SANDSTONE PRECINCT

23-39 BRIDGE STREET
SYDNEY NSW, 2000

**PROPOSED PLANS - LANDS BUILDING -
LOWER GROUND, EDUCATION BUILDING -
BASEMENT 01**

FOR APPROVAL

4 LEVEL 9 GARDEN VILLAS MAINTENANCE ACCESS DOOR
1:20

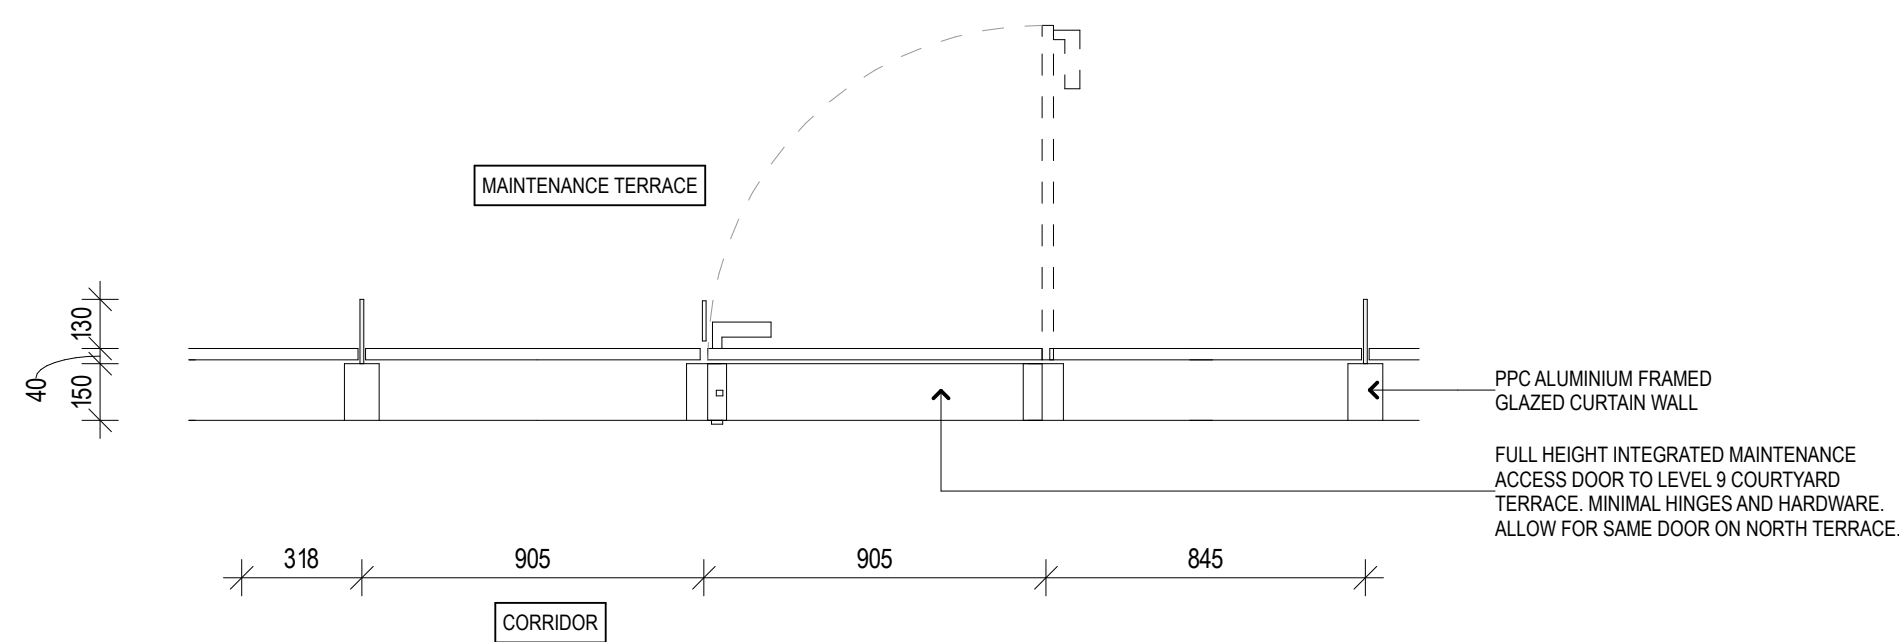
| 01 | ADDED BACKSPAN ABOVE CEILING LEVEL |

ISSUED STATUS		FOR APPROVAL		
SCALE @ B1	DRAWN	APPROVED	FIRST ISSUE DATE	
1:20	PH	DR	10/12/19	
PROJECT CODE	SHEET NO	REVISION		
19050	SP-DA-G-4104	6

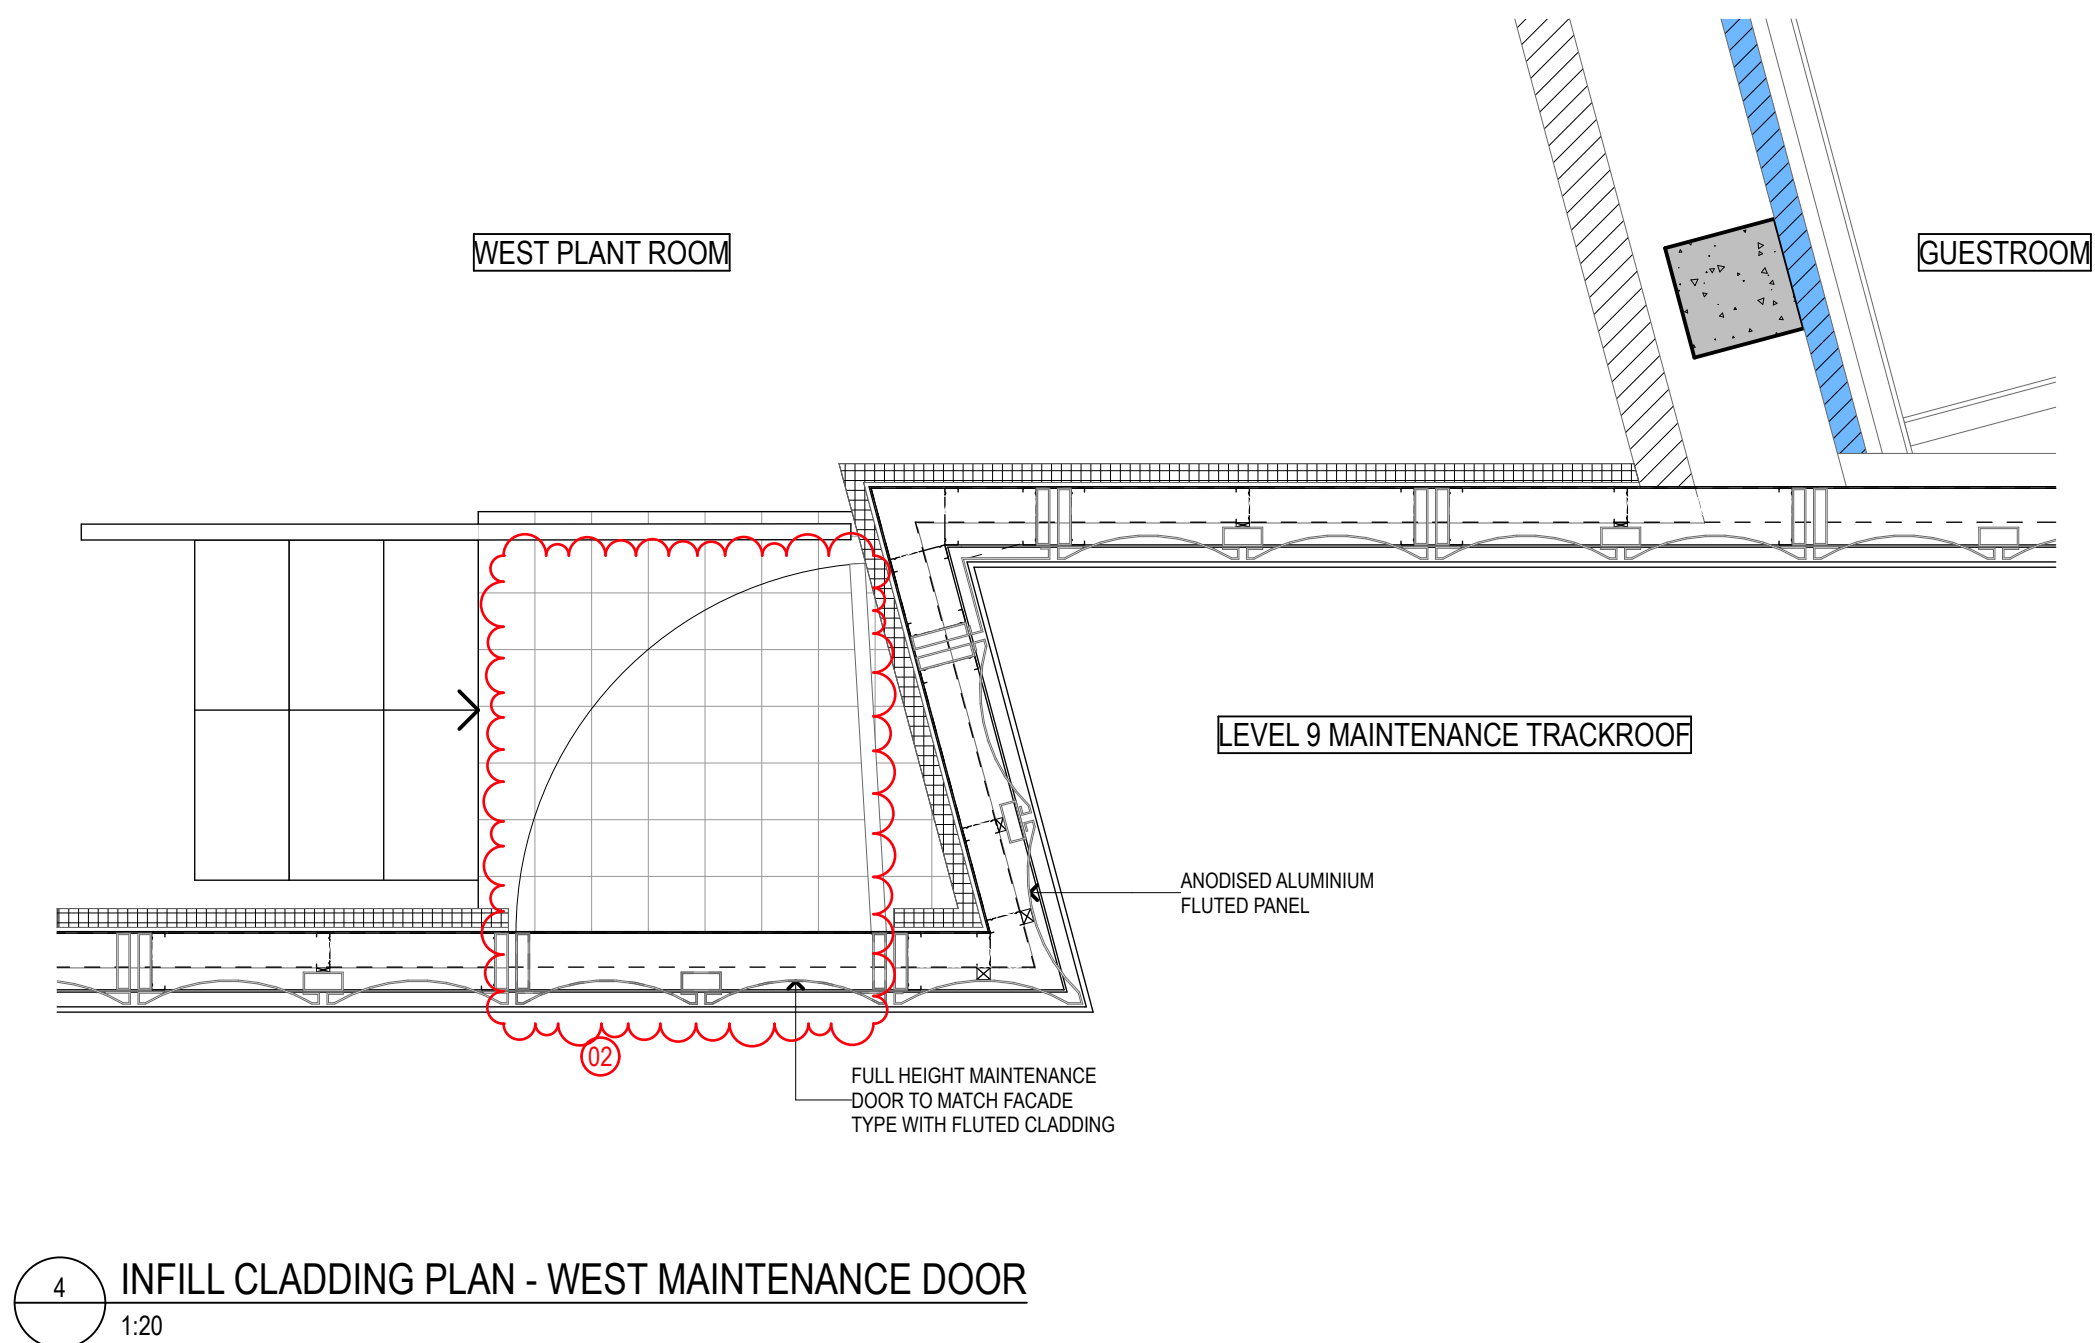
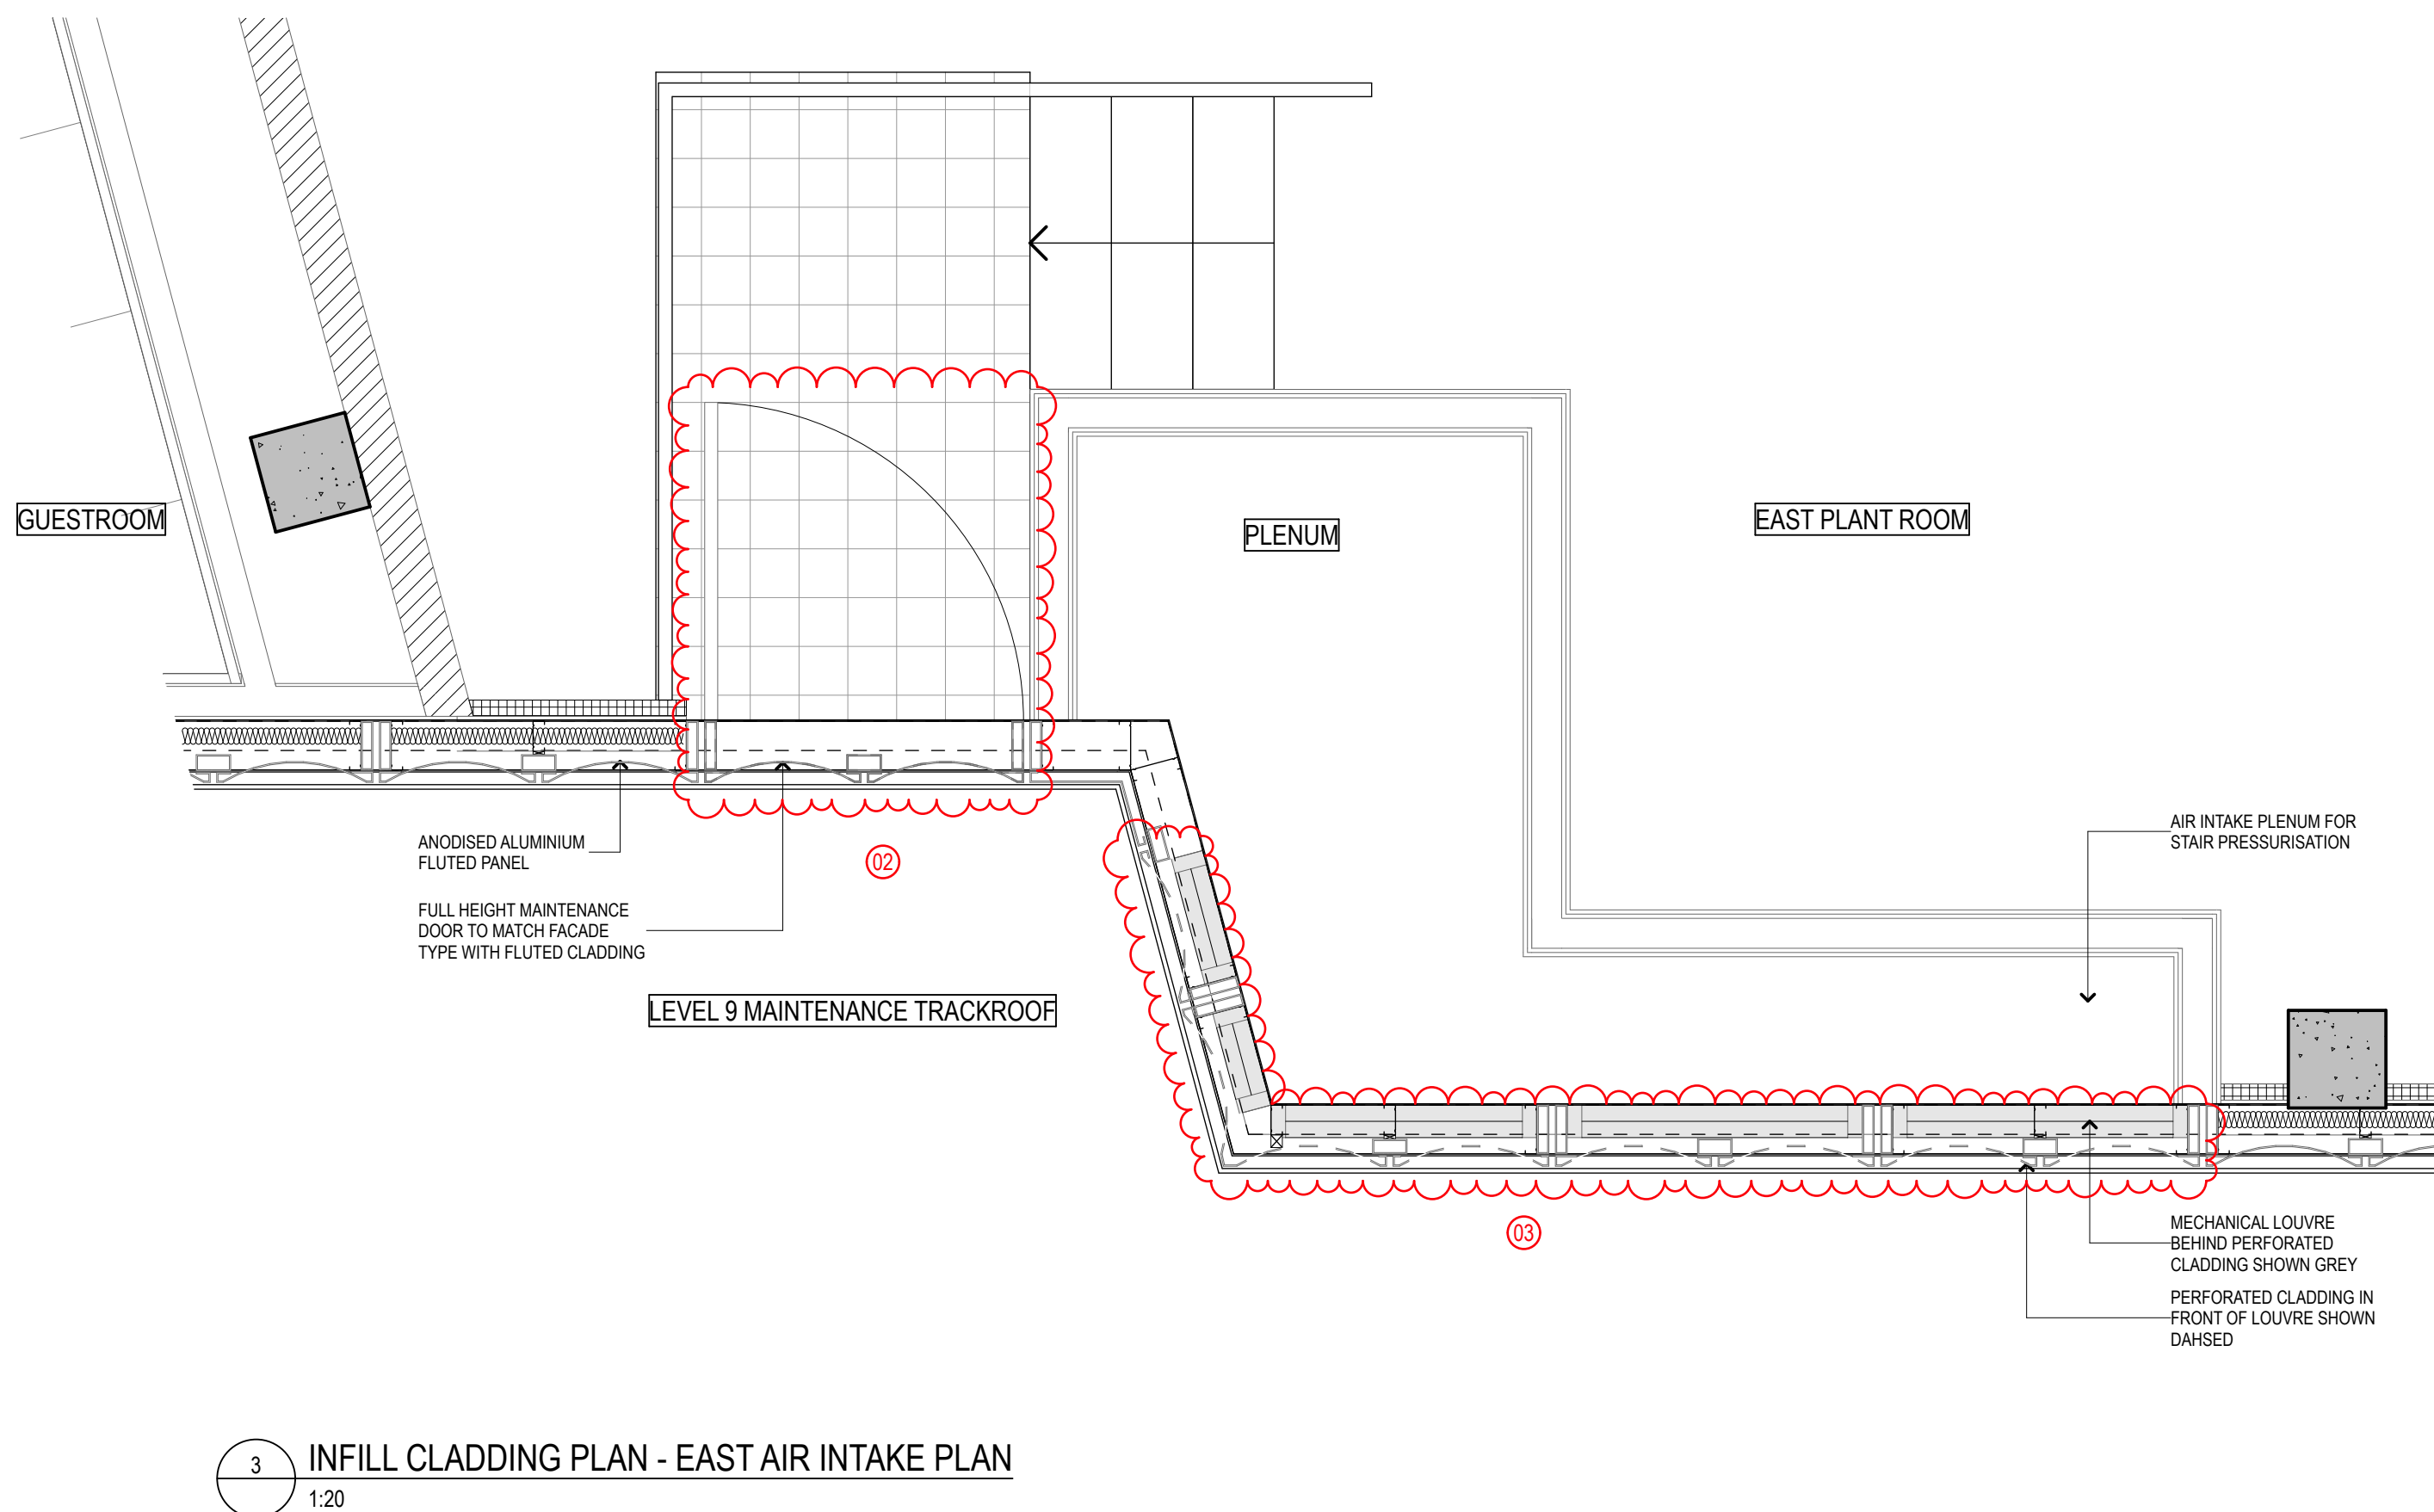
- CHANGES LEGEND:
- 01 ADDED BALUSTRADE
 - 02 ACCESS DOOR RELOCATED
 - 03 PERFORATED PANELS RELOCATED
